**APPLICATION FOR RESOURCE CONSENT RMA/2023/597
ADDRESS 130 BOWENVALE AVENUE**

Thank you for your application for resource consent for 35 lot fee simple subdivision on the above site, which we received on 11th April 2023.

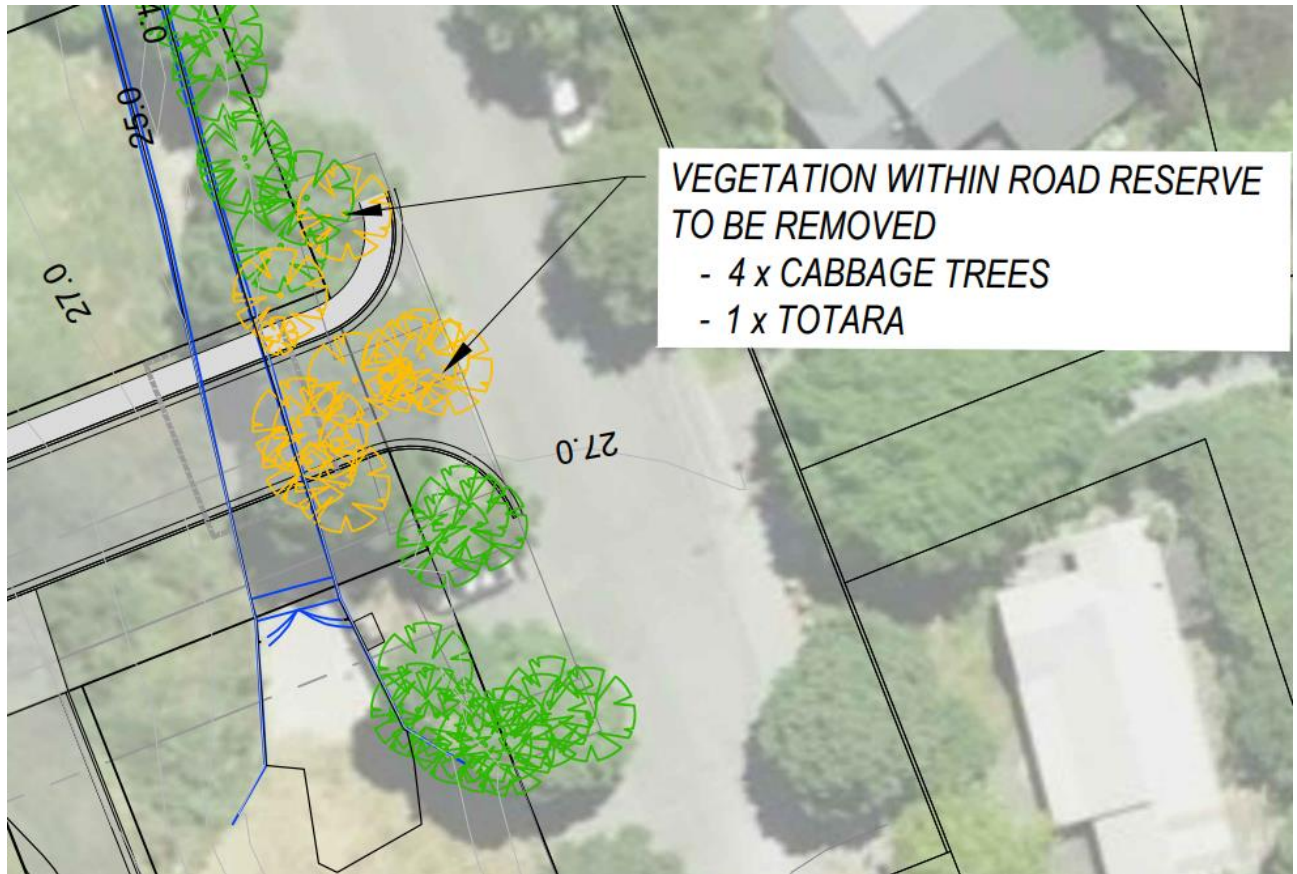
2. Are the defined patios areas on Lot 35 going to become decks or terraces? If yes please specify if they will be 800mm over existing ground level.

This is to determine setback and site coverage compliance.

Dwelling is on hold

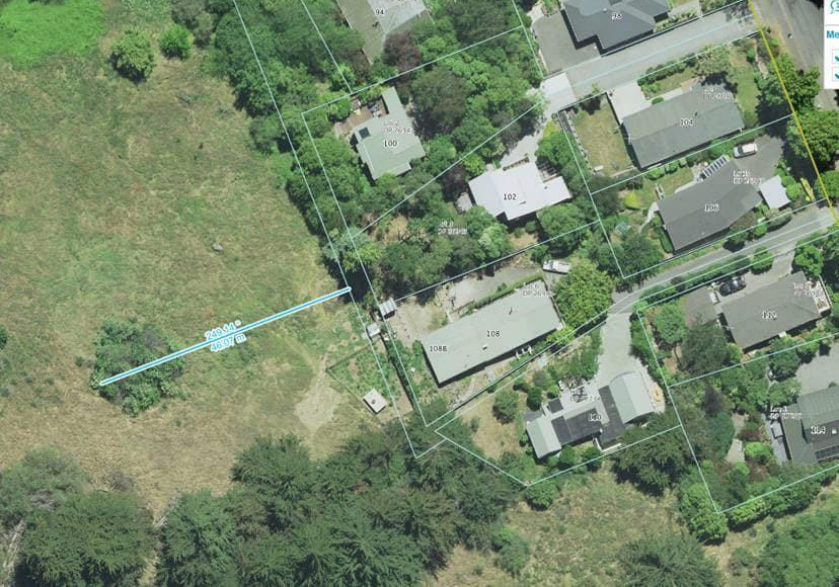
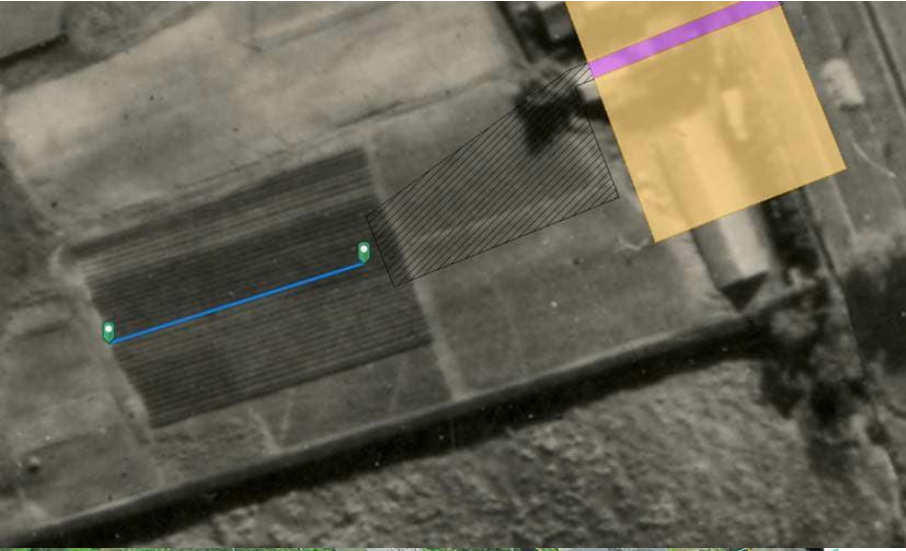
31. Please provide a comprehensive analysis of the stormwater mitigation proposed and the

The peak flow increase is 51.32l/s for the 50-year ARI with a 10-minute storm duration. Based on a 27 hour storm the peak flow increase is 4.96l/s based on a rainfall intensity of 7mm/hr (HIRDS V4 RCP8.5).

Due to the size of the contributing catchment approx. 340 hectares, the increase in flows and volume generated from an additional 4,250m² of impervious area (0.125% of the total catchment) will have minimal effect on flood levels.

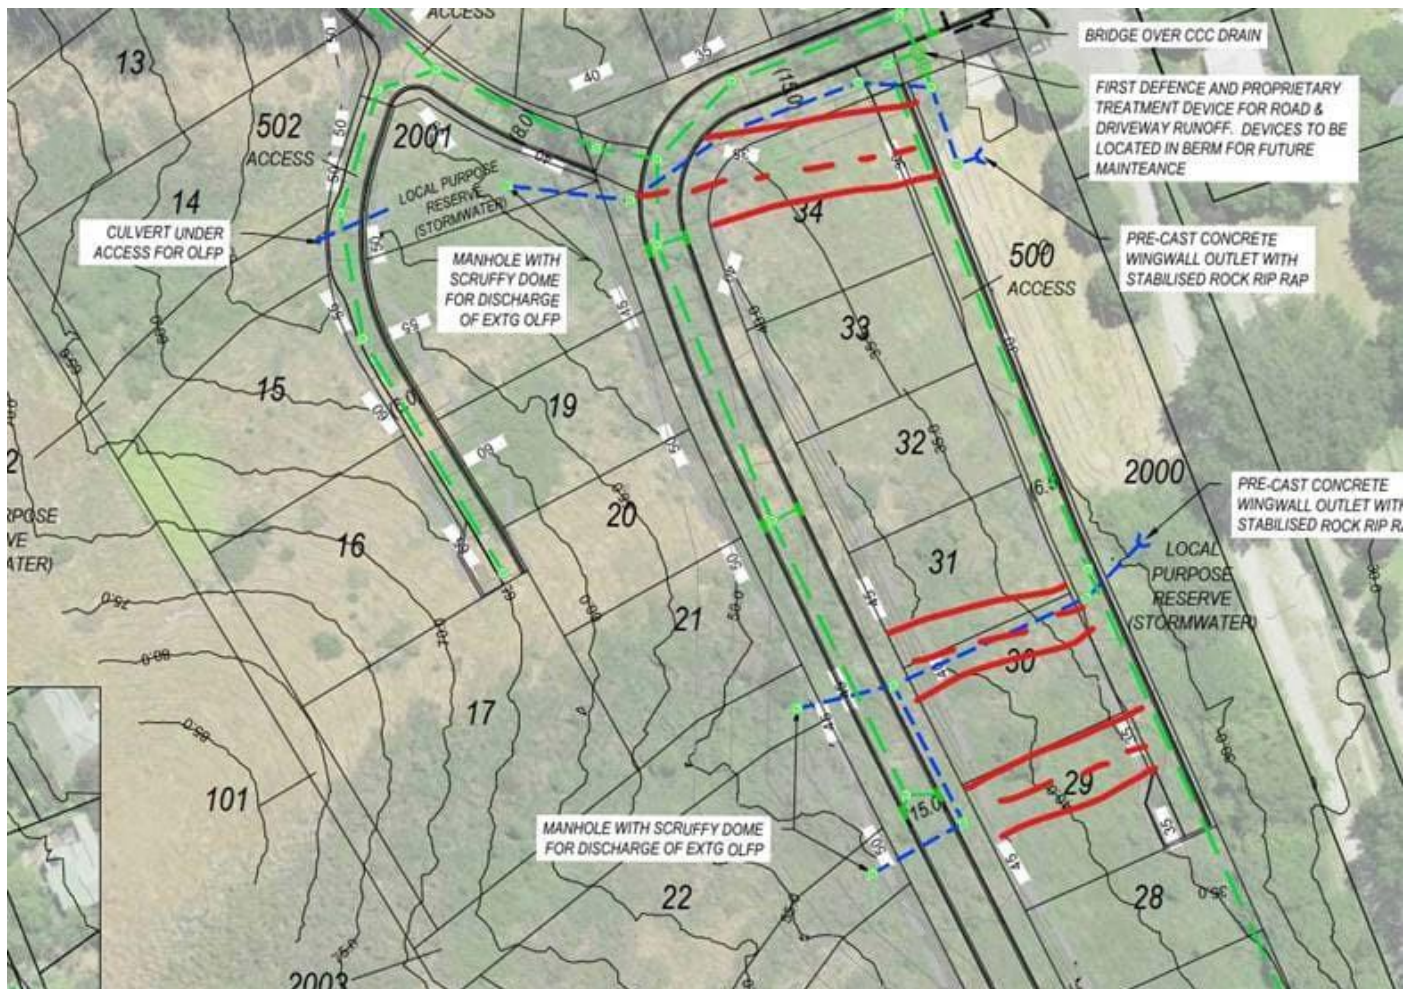
- The current setback proposed from of the Hill waterway is not accepted by the specialists. It would be optimal for the compliant setback to apply (20m total area measured from the centreline of the waterway to 10m out on both sides), however a further discussion is recommended on this matter;
- The piping of the hill waterway from the proposed road within the development site is not supported due to the steepness and terrain of the area; **The subdivision design has been amended to retain the two southern hill waterways and only pipe where required under the road and ROW. The lower section of Sibleys Branch drain No. 15 cannot be retained due to the alignment being at the location of the existing legal access to the neighbouring properties and proposed future road.**

The total setback for any dwelling is 10m either side of the waterway.

project no / drawing no: **2022_053 / 002**

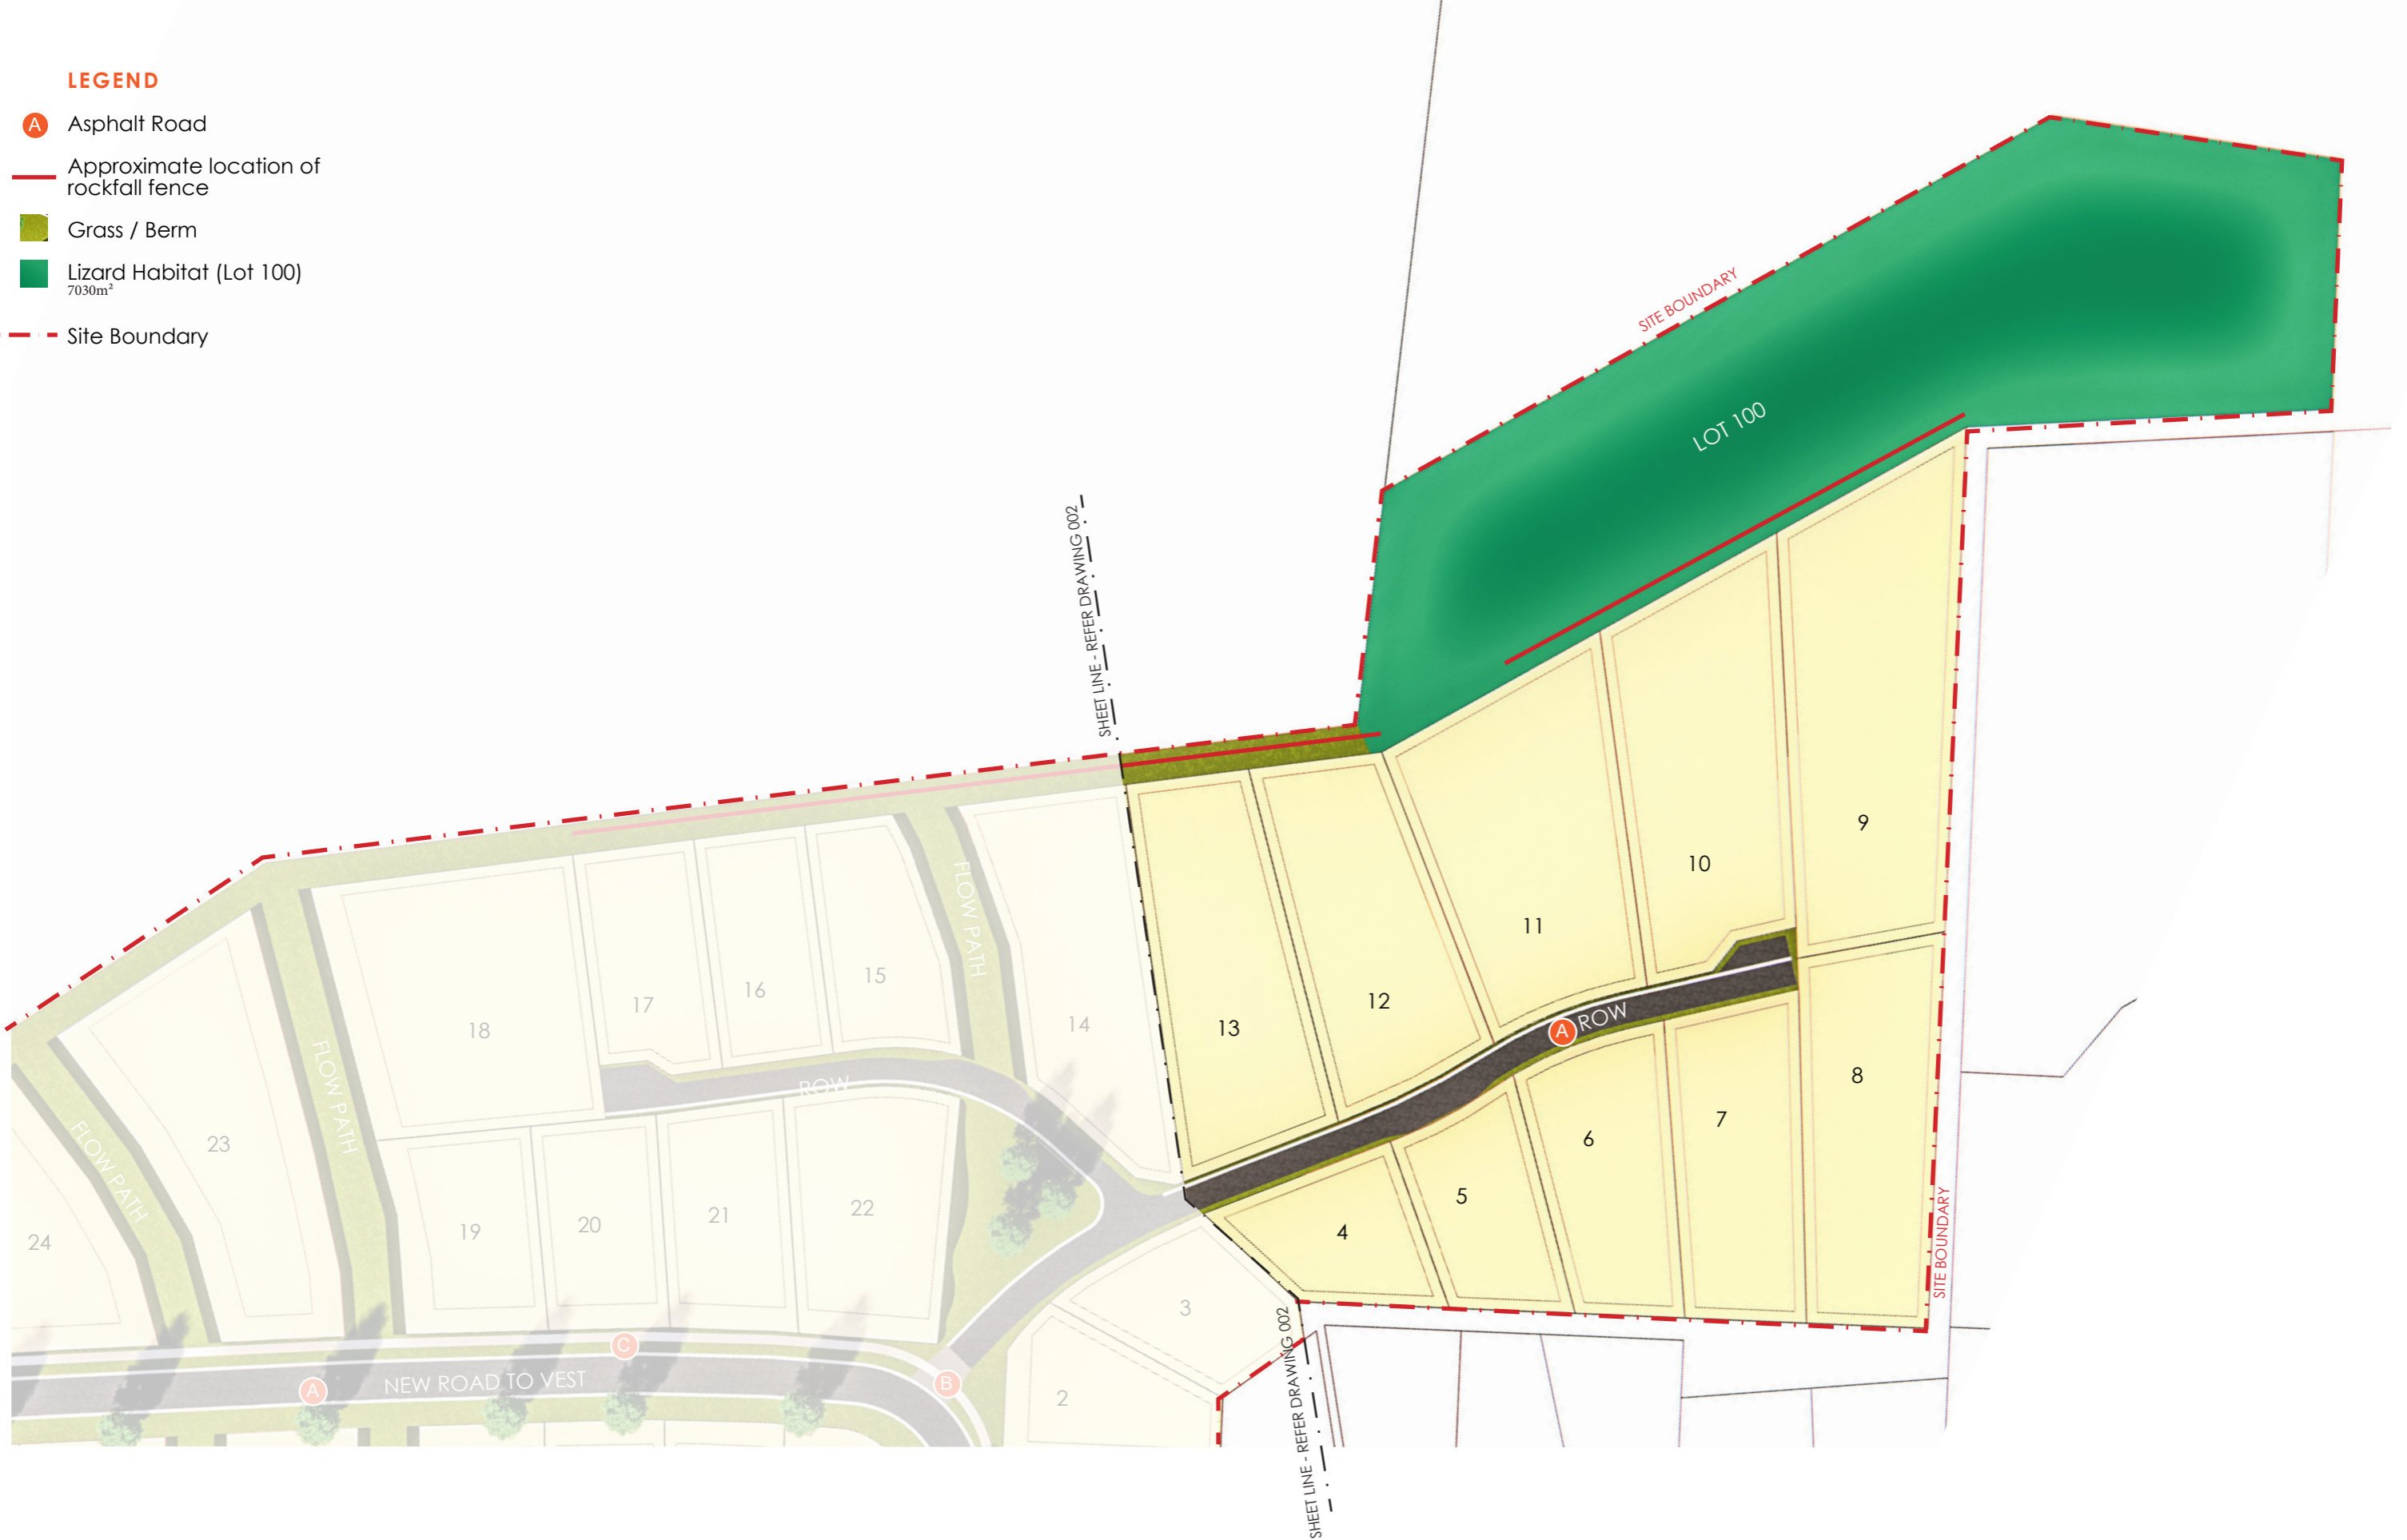
14. Please provide detailed landscaping plans which clearly identify;
- The mitigations as outlined by the wildlands report (if proposed);
 - Where replacement trees are proposed to be located (approximately)

Refer amended Landscape Plan. Rev D

Figure 2-1: Bowenvale Avenue / Road 1 Intersection

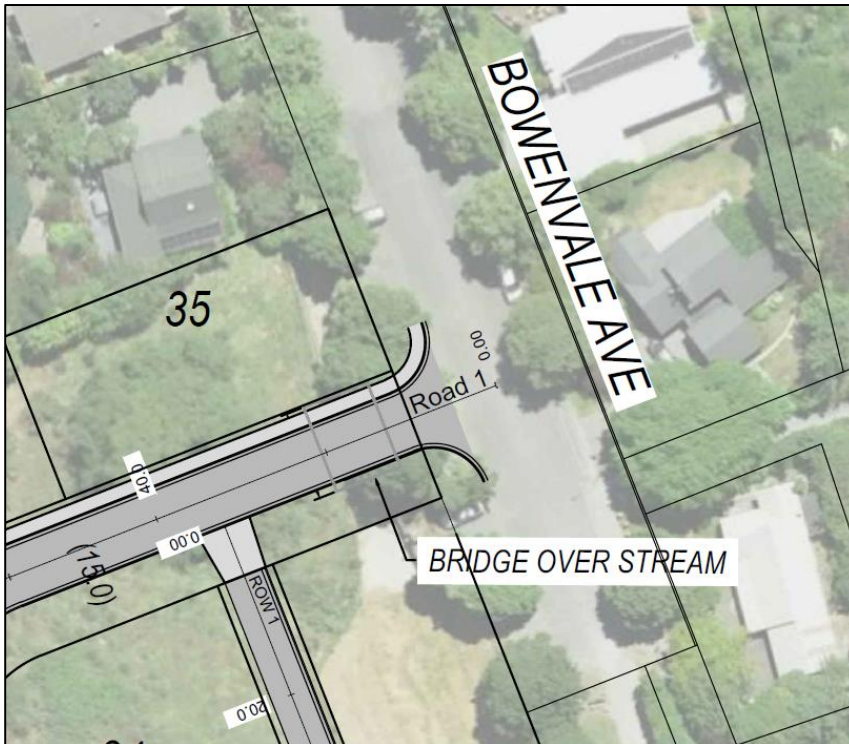
Road 1 is proposed to meet Bowenvale Avenue at a T-intersection (**Figure 2-1**). It is considered that a basic T-intersection will be appropriate however there will be several matters to be considered through the detailed design stage.

Figure 2-6: End of Road 1

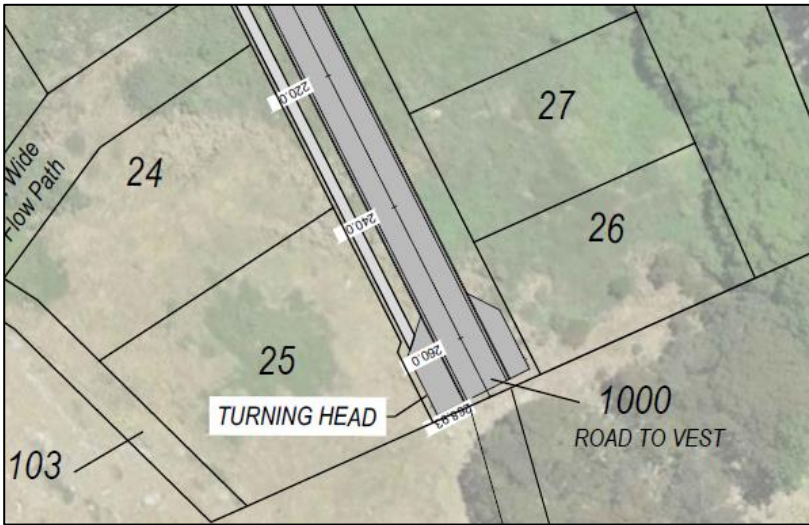
The Road 1 turning head (**Figure 2-6**) is indicated to be approximately 14m wide and 12m long. This is smaller than a standard turning head in a residential area (typically 19m diameter as per NZS4404). There is a concern that a rubbish truck will not be able to turn around at the end of the road and may be required

to reverse over a long distance. A reversing truck is a hazard to all road users and particularly vulnerable road users.

Figure 2-8: Indicative Edge Protection Opposite ROWs

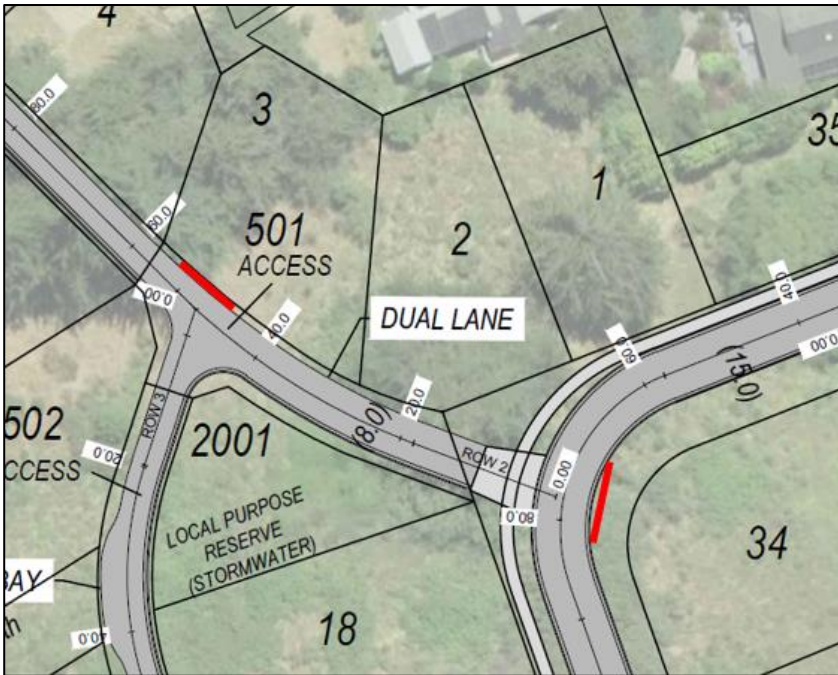
With the steep grades on ROW 2 and ROW 3, there is the potential for a driver to lose control of their vehicle in wet or icy conditions. There is a concern that an out-of-control vehicle could continue off the end of ROW 3 or ROW 2 into a property below. **Figure 2-8** indicates locations where vehicle barriers should be considered (noting these are indicative and a full design will be required to determine the length of need at these locations).

Figure 2-9: ROW 1

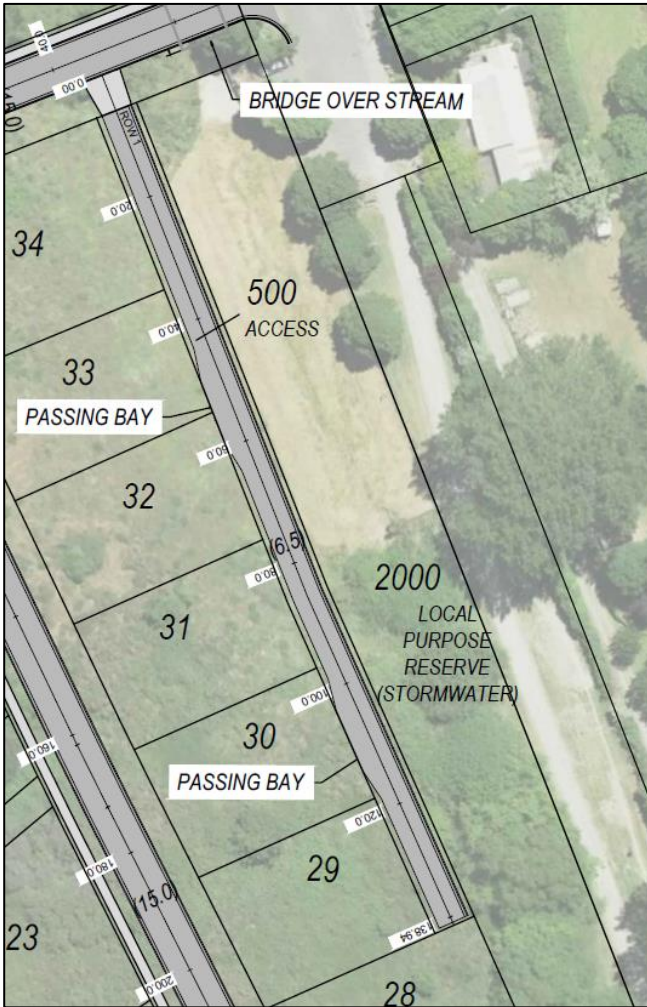
ROW 1 (**Figure 2-9**) is proposed to run along the ridge above the existing stormwater area shown in **Photograph 2-4**. This has steep sides and there are concerns that a vehicle, pedestrian or other road users could fall off the ROW. Also vehicles being manoeuvred out of Lots 29-34 could be mistakenly driven off the edge. The stormwater channel has steep, non-recoverable gradients and in the event that high levels of water are present, there is a risk of drowning. The form of edge protection and its purpose, i.e. to stop vehicles or to keep pedestrians out, should be considered.

Figure 2-10: Instances of Road Level above Surrounding Ground Level- Road 1 Left, ROW 3 Right

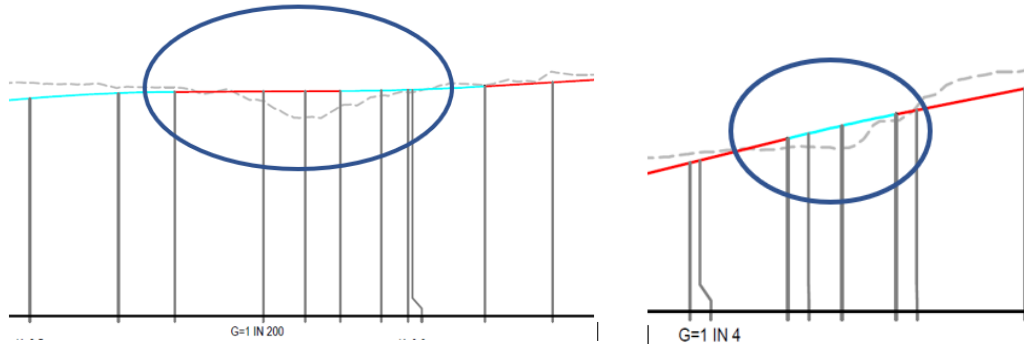
Other locations have been identified, such as those two highlighted below, where it appears that the level of the road will be above the level of the surrounding ground. A review of the subdivision design should be carried out, with locations for edge protection to be identified and considered further through detailed design.
